PROJECT: WEST PREP ACADEMY ELEM. SCHOOL ADDITION

SUBMITTAL: 1ST

CITY OF LAS VEGAS		DATE:
INTER-OFFICE MEMORANDUM		August 26, 2015
TO: Land Development Services Department of Building & Safety		FROM: Albert Sung, P.E. Flood Control Project Engineer Department of Public Works
SUBJECT:	Drainage Study for:	
	West Prep Academy Elementary School Addition	
Cross Streets:	SEC of Lake Mead Blvd. & Pink Rose St.	
File Number:	F:\Depot\DSMemos\DS4747A.doc	
Parcel Number:	139-21-314-001	
Zoning Action:	PMP-60740	
FEMA Flood Zone	YES	NO X
Proposed Storm Drain	YES	NO X
		COPIES TO: GCW Engineers Surveyors Clark County School District Bart Anderson, P.E., DevCo CCRFCFCD CNLV

FOR CONTINUATION SEE SHEET NO. C9

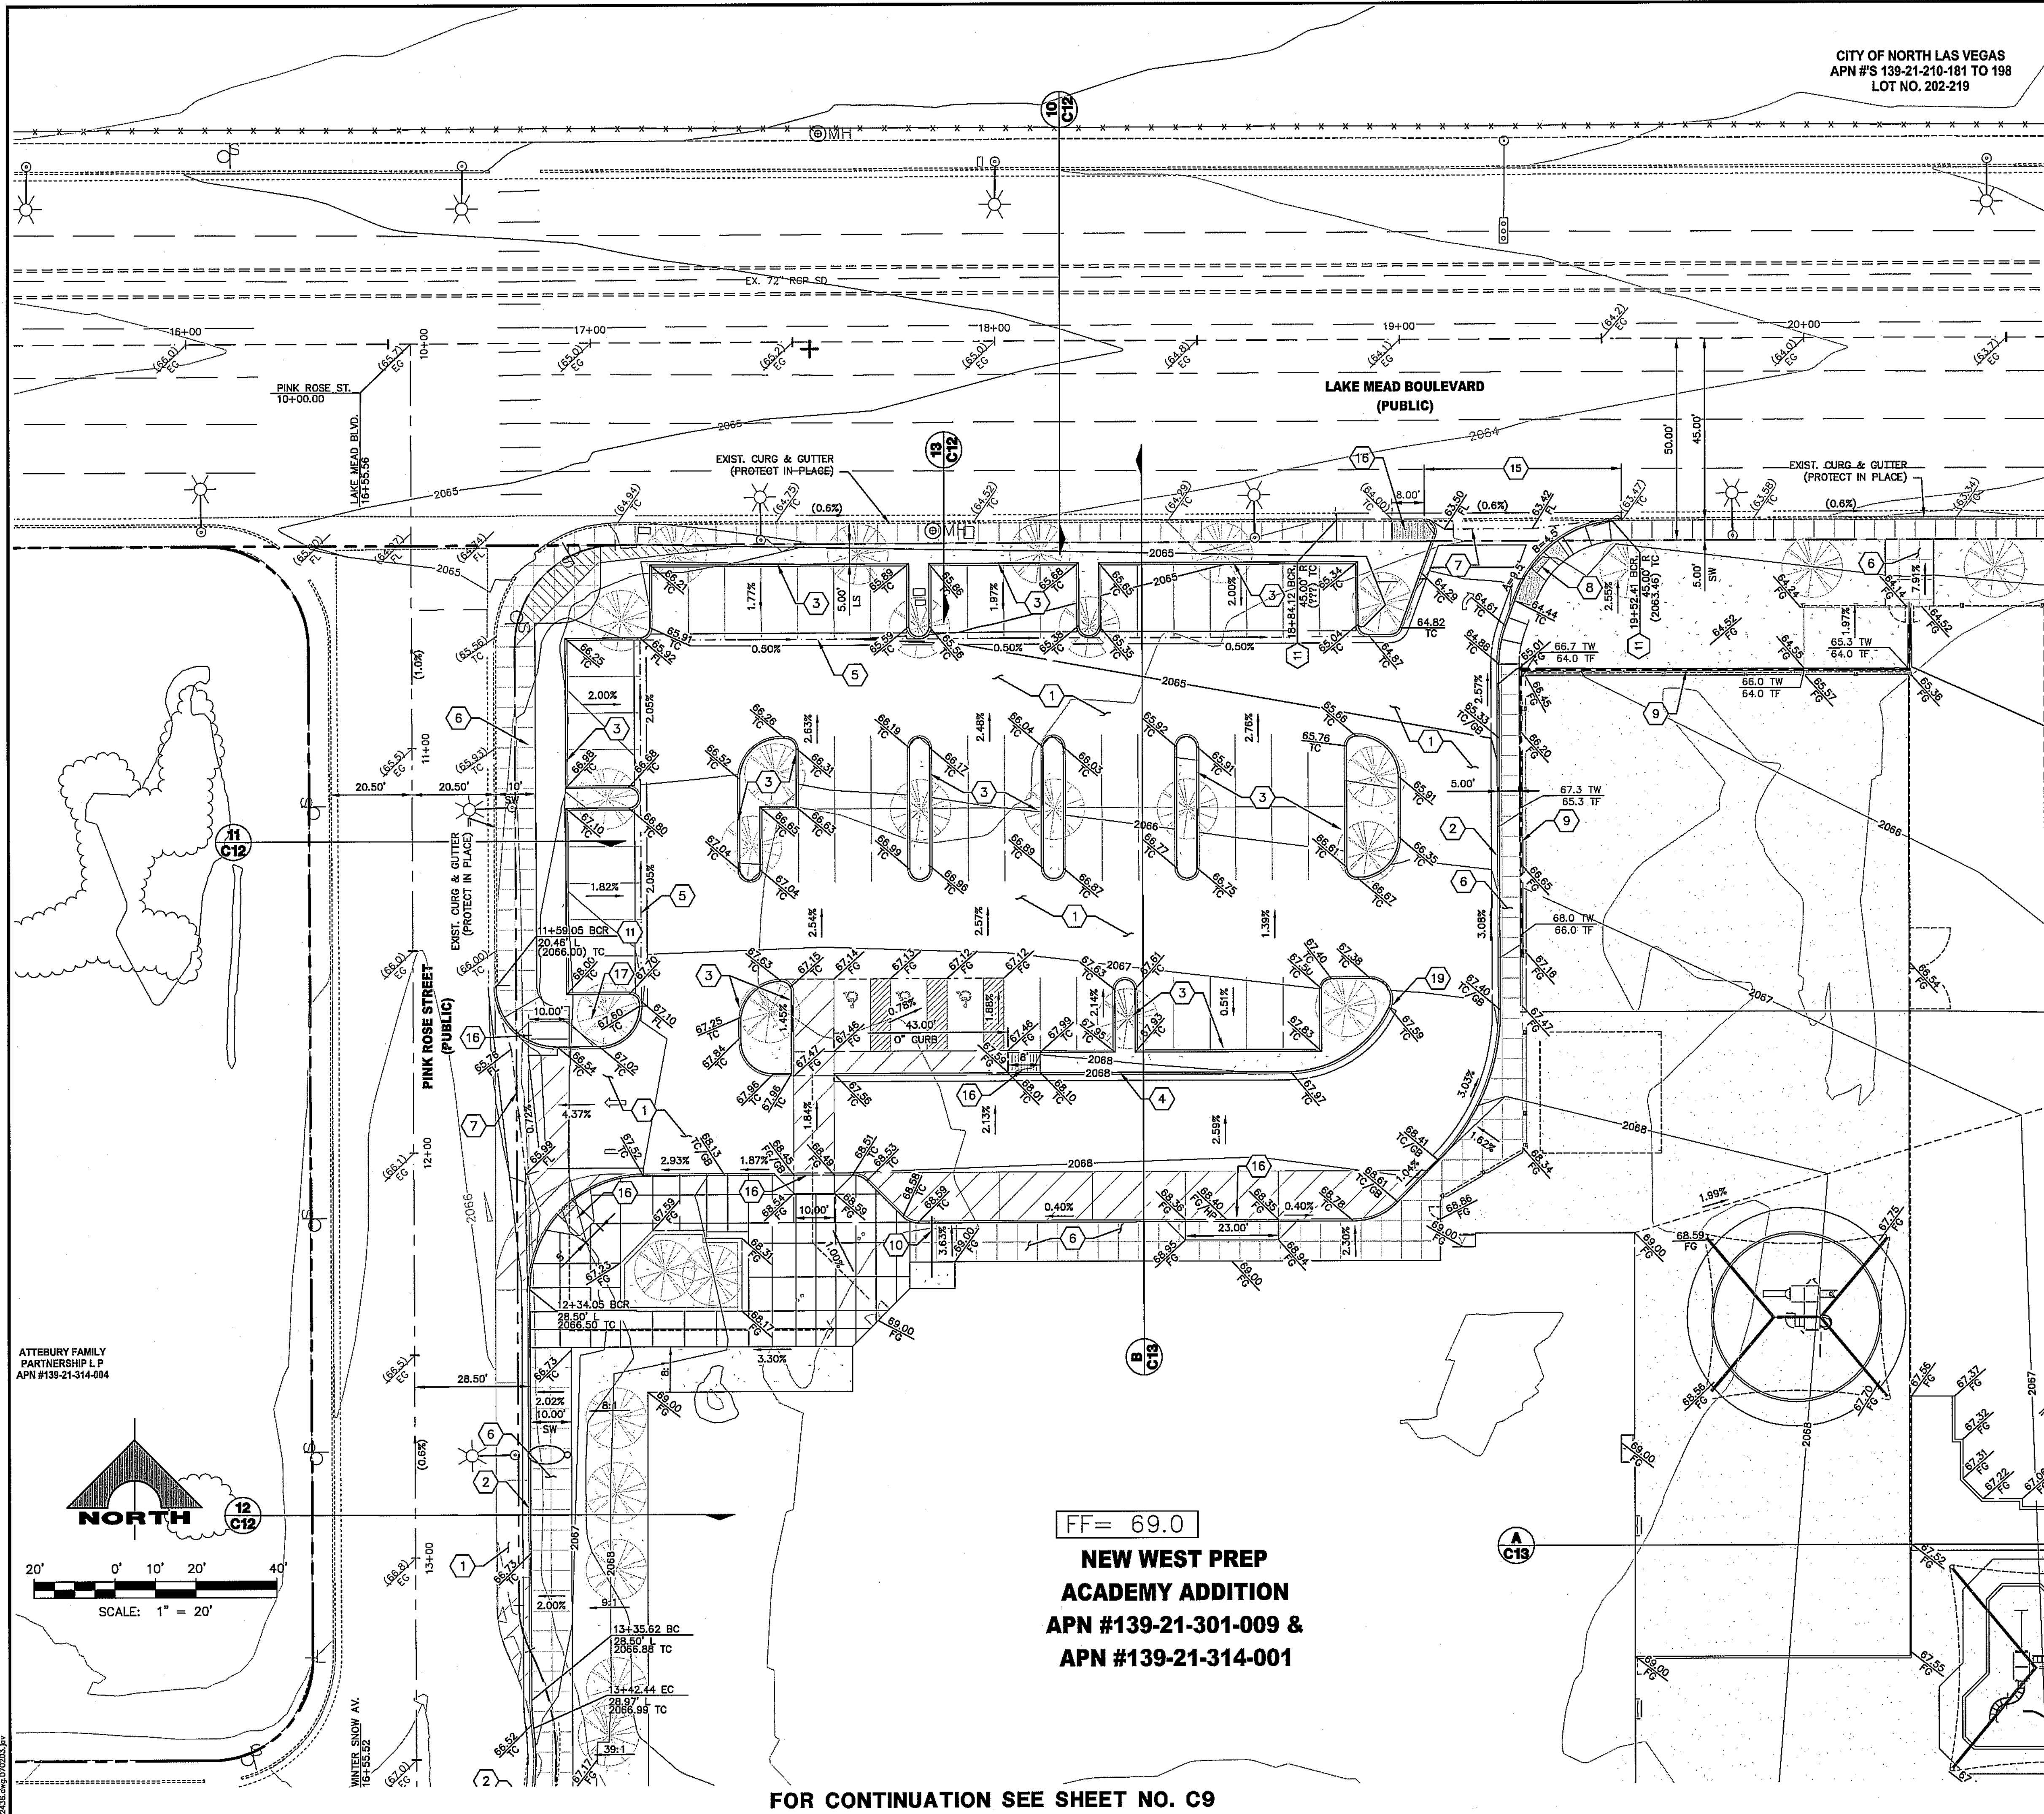
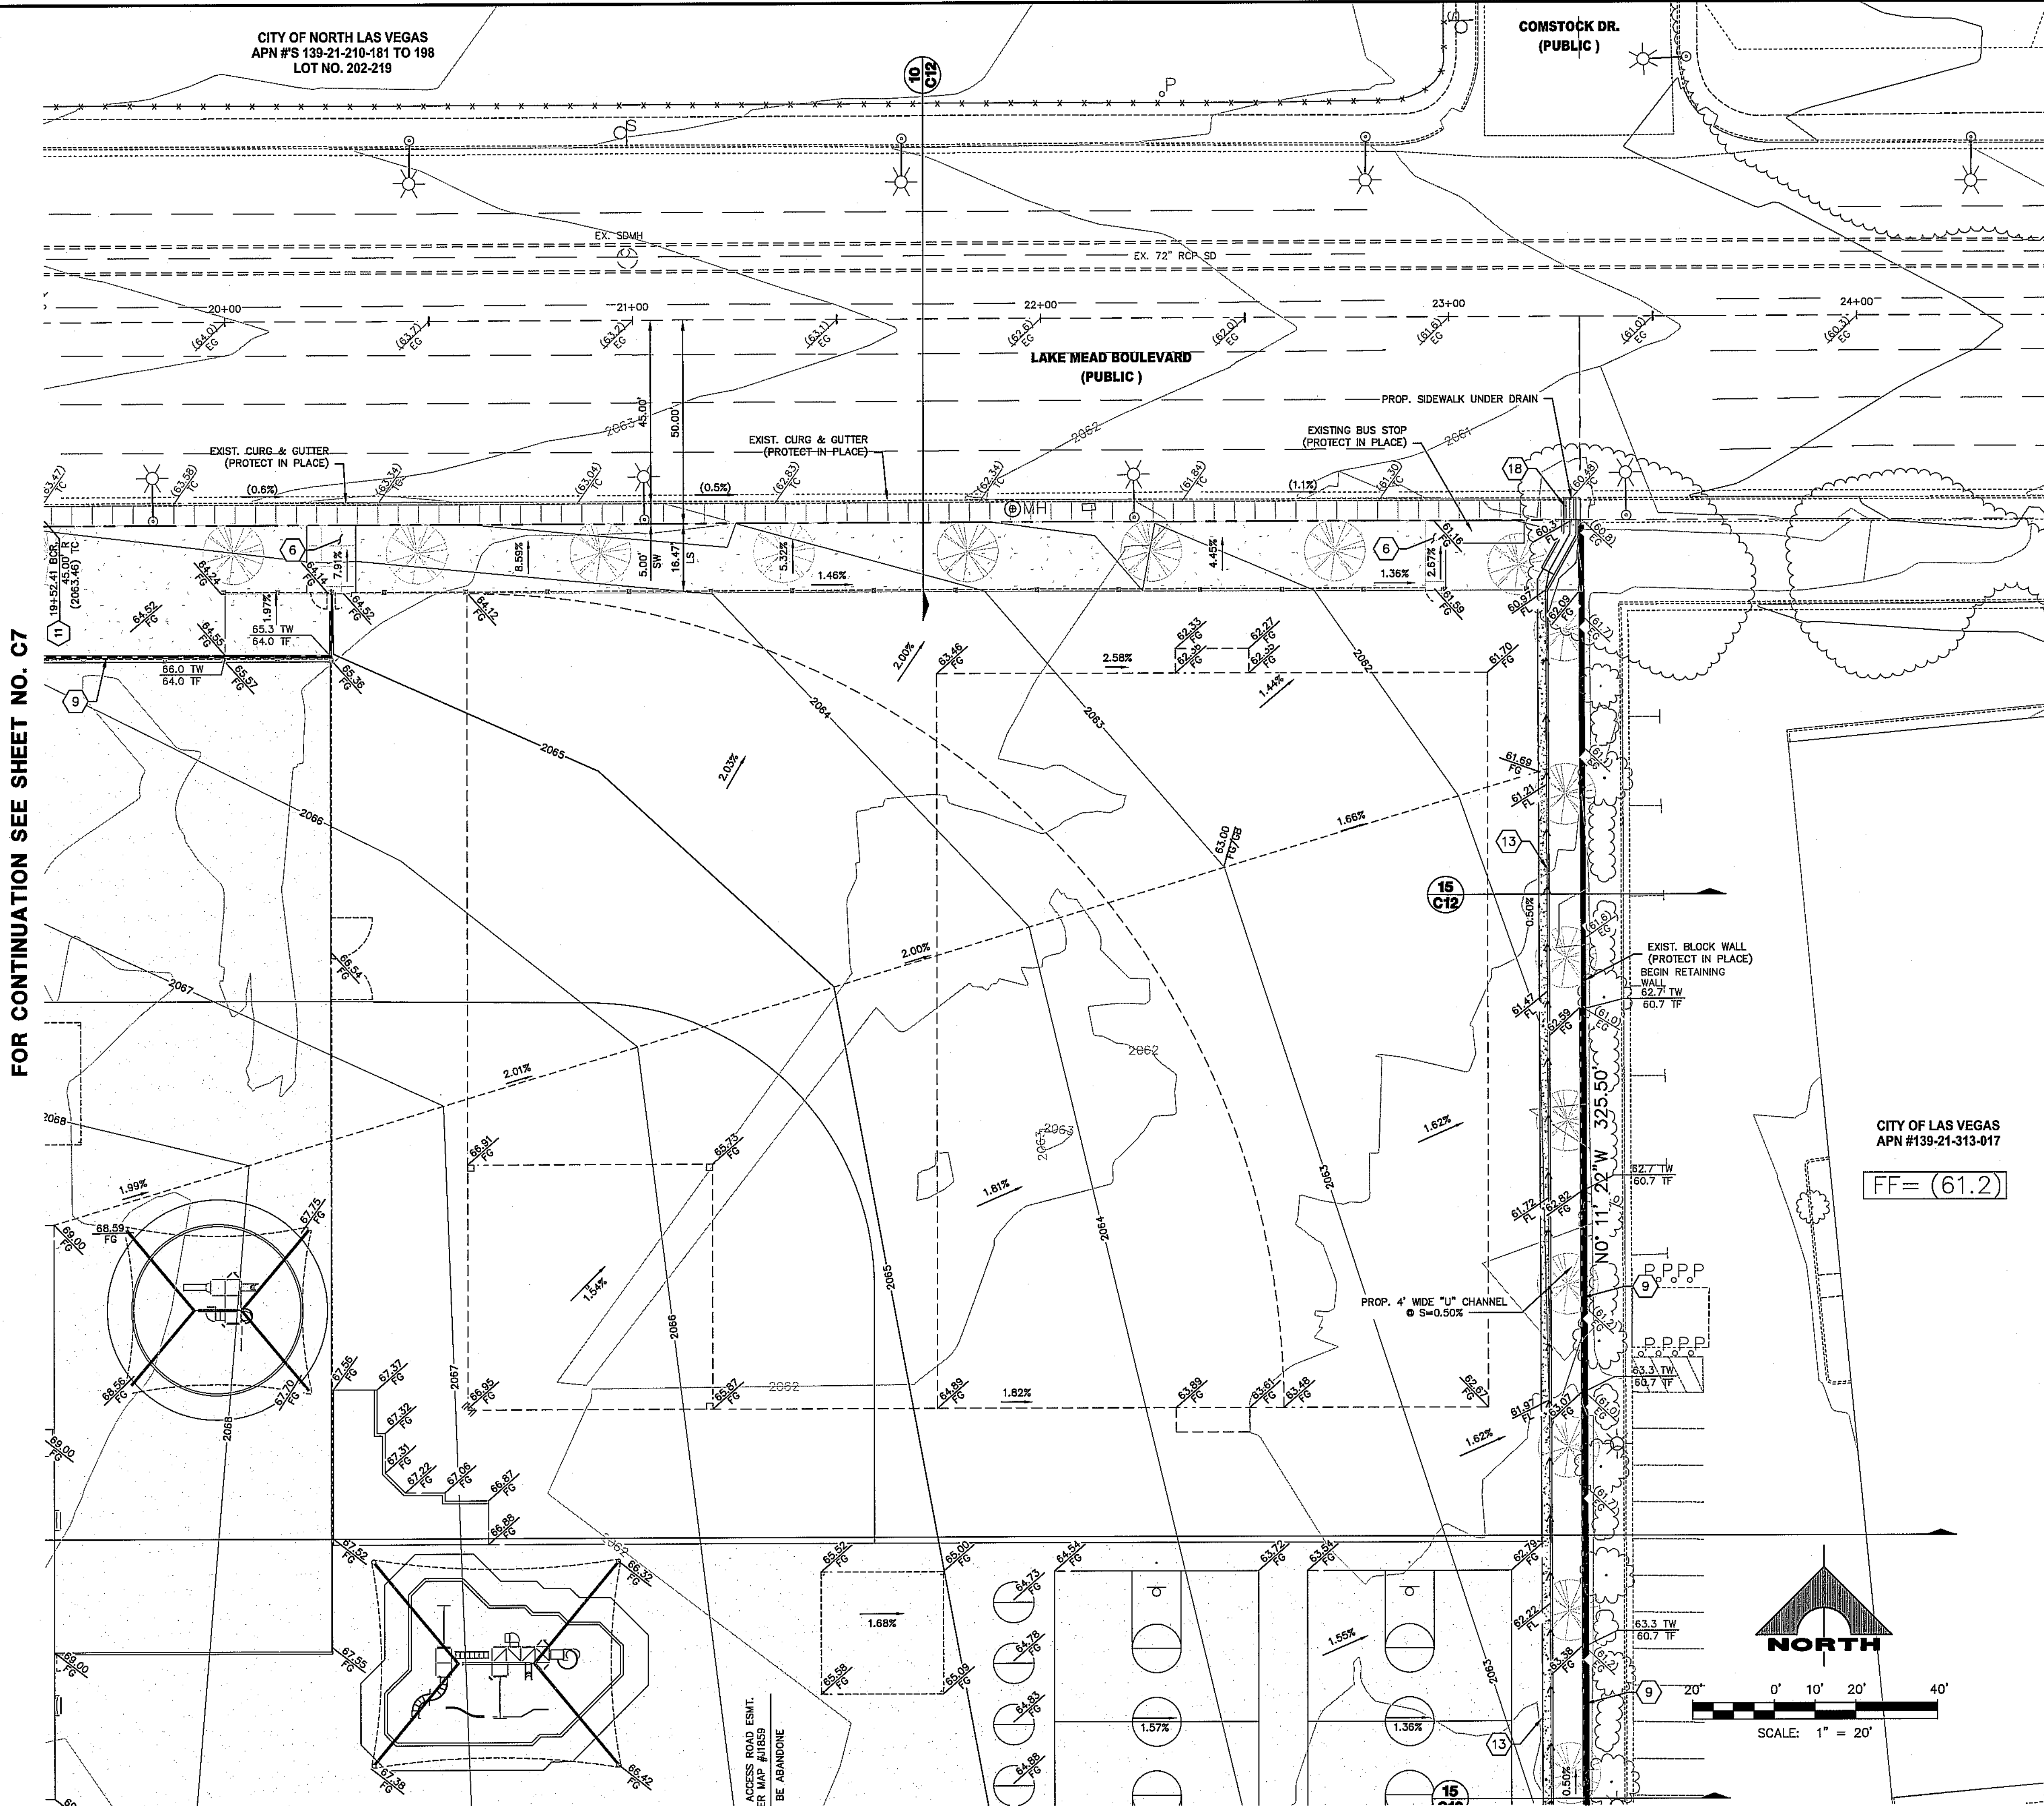
8. Label an existing storm drain in *Lake Mead Boulevard* with *City of Las Vegas* recorded drawing number on *Sheet C8* and *Sheet C9*.
